Item ID: D412-664-203

Item Name: Crosstube Aft

DRAWING NO. D412-664-243	TITLE CROSSTUBE ASSEMBLY (412 HI AFT)	REV. E	DART AEROSPACE LTD ENGINEERING ORDER		D.E.O. NO. D412-664-243-E-1	SHEET NO. SHEET 1 OF 2	SCALE NTS
DRAWN	CHECKED	MFG. APPR.	APPROVED	DE APPR.			
DATE 11.03.31	DATE 11/03/31	DATE 11.03.31	DATE 11/03/31	DATE 11-03-31

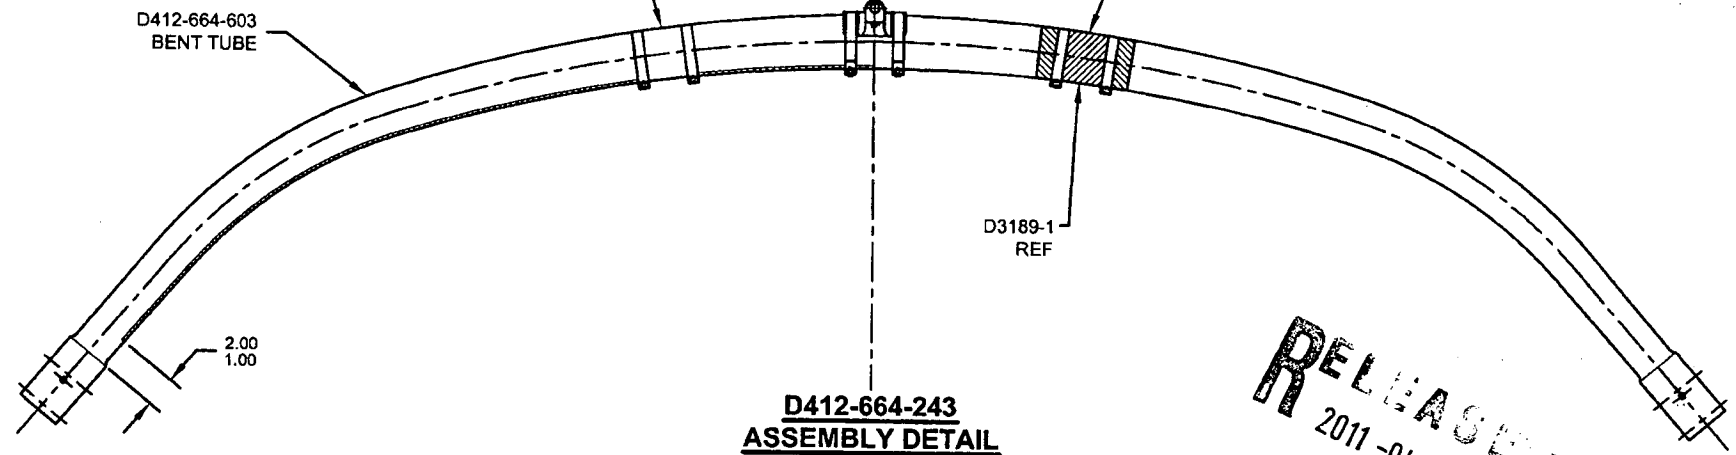
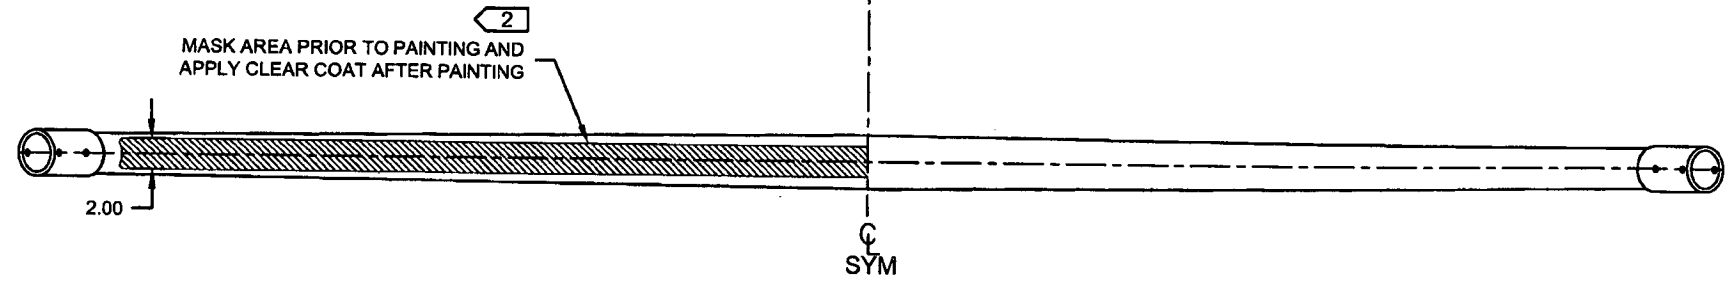
D3189-1 CHAFING SHIELD (1, INSTALLED OVER PROSEAL 890)
MS21920-28 CLAMP, 2X
2 PL

WAS:

D2856-600-1009 ABRASION STRIP
D3189-1 CHAFING SHIELD (1, INSTALLED OVER ABRASION STRIP)
MS21920-28 CLAMP, 2X
2 PL

IS:

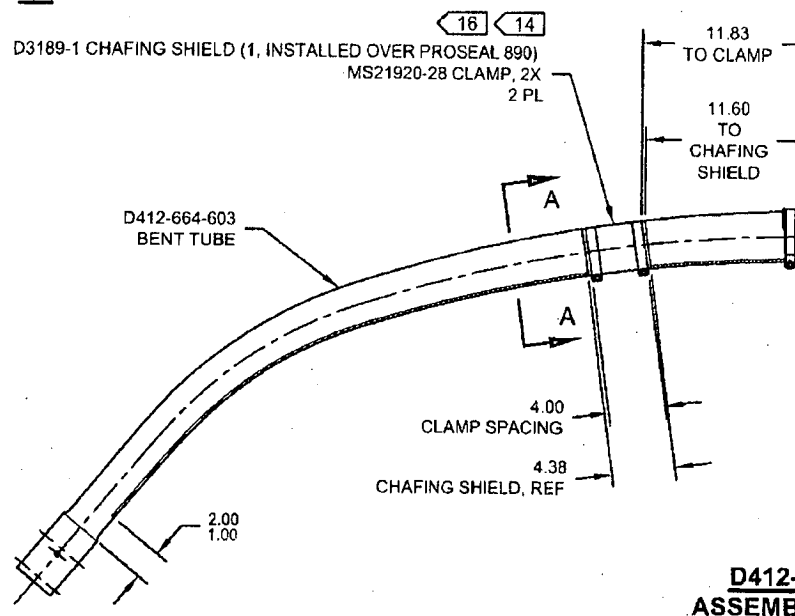
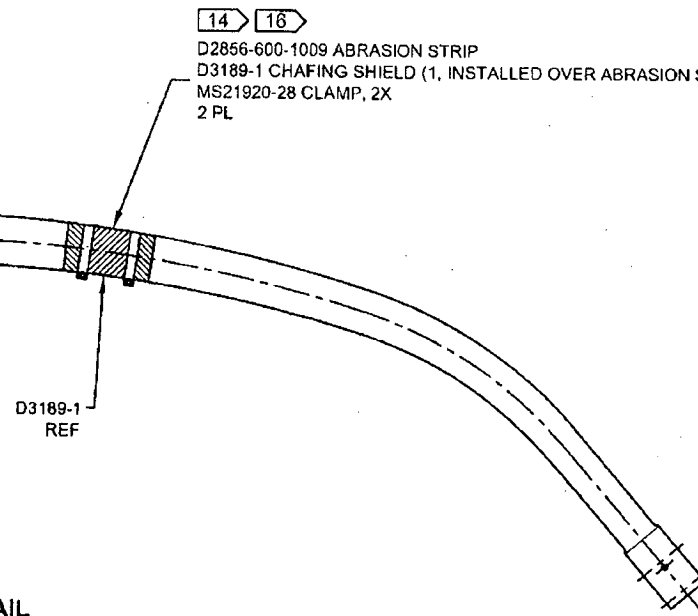
D3189-1 CHAFING SHIELD (1, INSTALLED OVER PROSEAL 890)
MS21920-28 CLAMP, 2X
2 PL

WAS:

D2856-600-1009 ABRASION STRIP
D3189-1 CHAFING SHIELD (1, INSTALLED OVER ABRASION STRIP)
MS21920-28 CLAMP, 2X
2 PL

**D412-664-243
ASSEMBLY DETAIL**

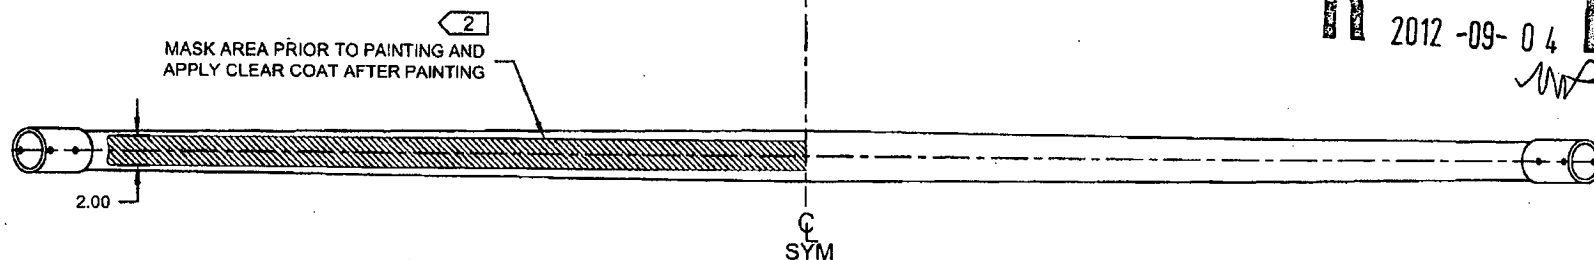
MASK AREA PRIOR TO PAINTING AND
APPLY CLEAR COAT AFTER PAINTING
